MEMORANDUM

RE: Proposed Licensure of WR 34-07247

You tasked me with review of WR Permit 34-07247, held by Mitchell Sorensen. I have reviewed the file for facts pertinent to development of WR License 34-07247.

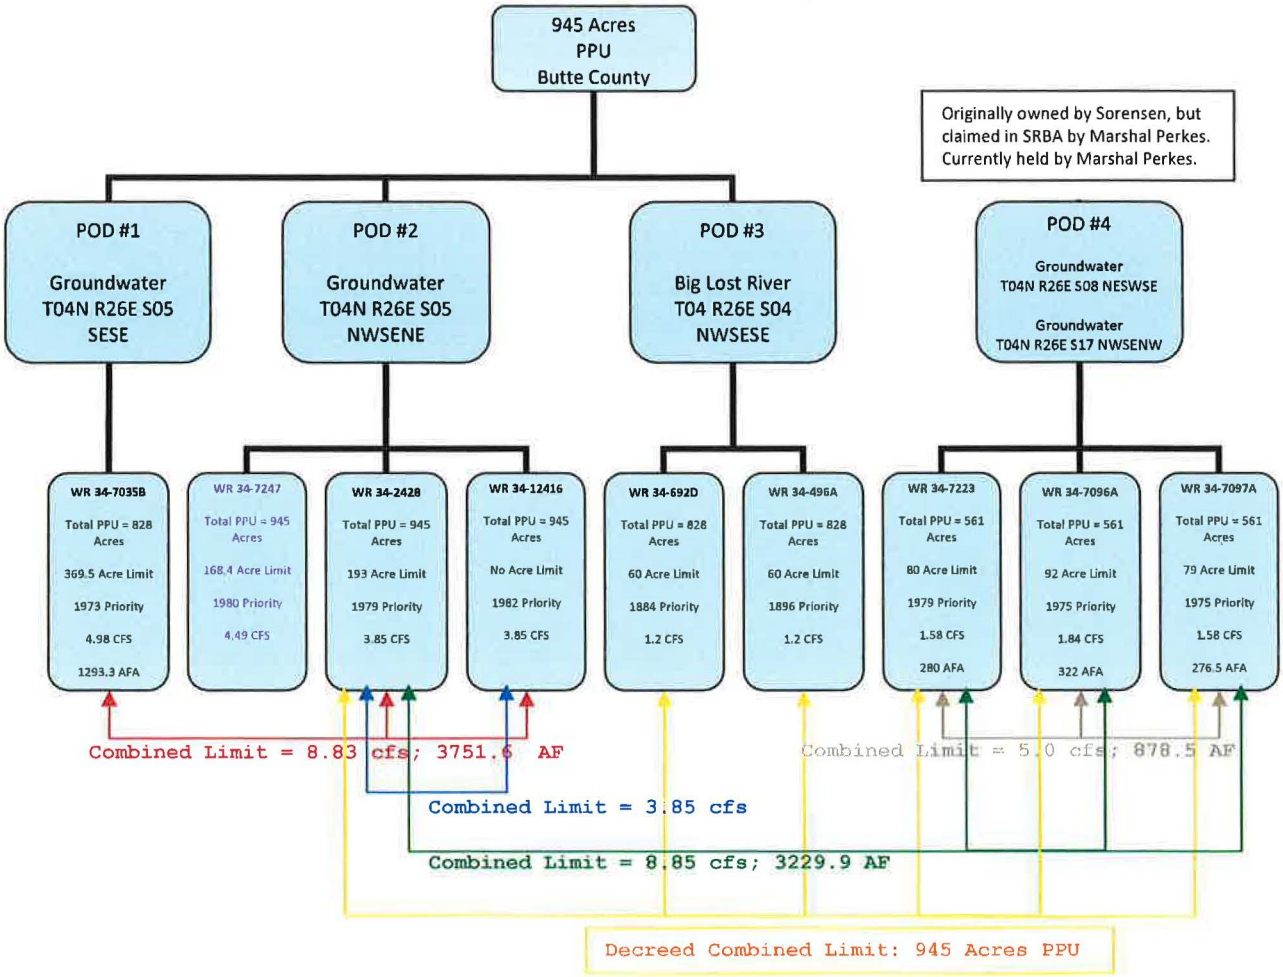
Overlaps. A thorough review of Mr. Sorensen's suite of water rights reveals that many of them are related via the same permissible place of use, and an assortment of combined limits. This information is conveyed in the chart below.

My review revealed a great number of combined limits amongst eight related water rights and one permit awaiting licensure. One quandary was amongst multiple partial decrees. All of the water rights listed under POD's #1, #2, and #3 overlap the same 945 acre place of use. All of the water rights listed under POD #4 overlap the same 561 acre place of use. The 945 acre place of use and the 561 acre place of use do not overlap. It was surprising to see the following condition:

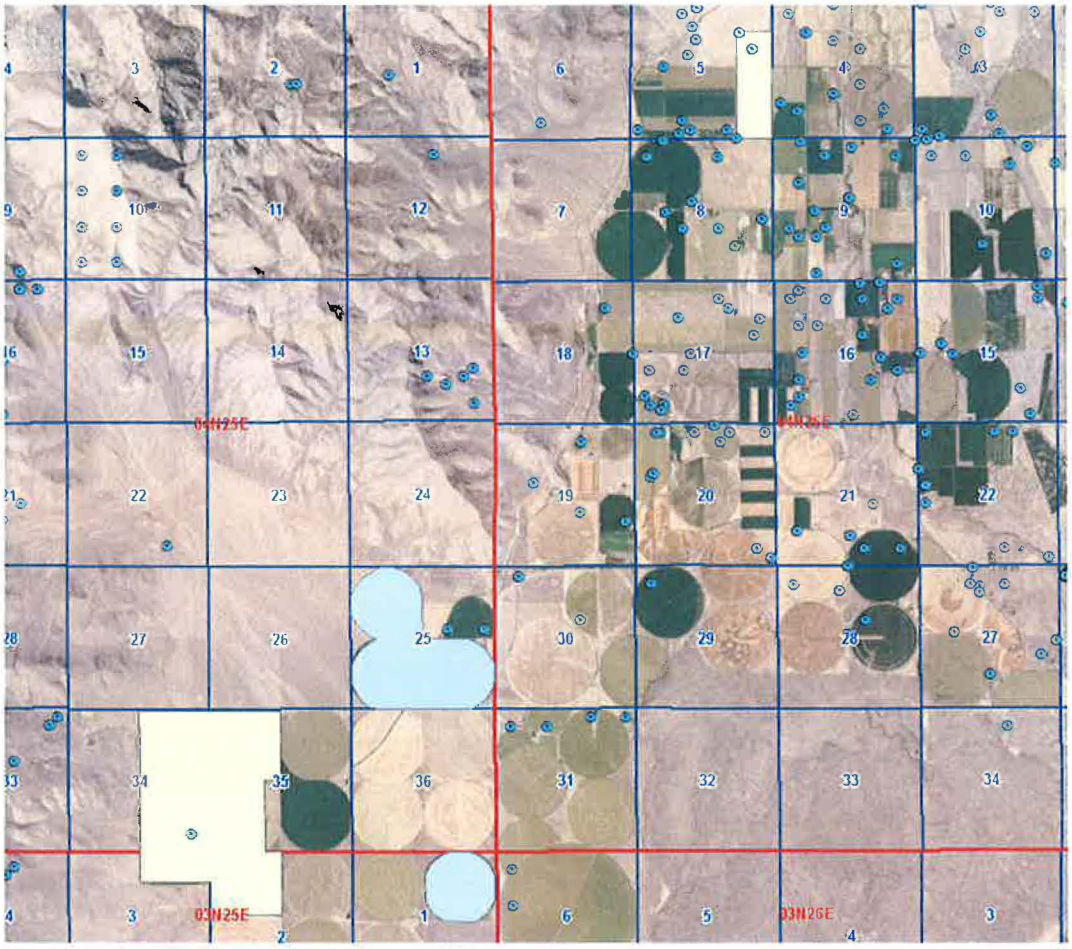
> "Use of this right with rights listed below is limited to the irrigation of a combined total of 945 acres within the place of use *described above* in a single irrigation season. Combined Right Nos.: 34-12416, 34-00496A, 34-00692D, 34-02428, 34-07096A, 34-07097A, 34-07223."

The place of use *described above* is the 945 acre place of use. In the map below, the 945 acre place of use is shown in yellow; the 561 acre place of use is shown in blue.
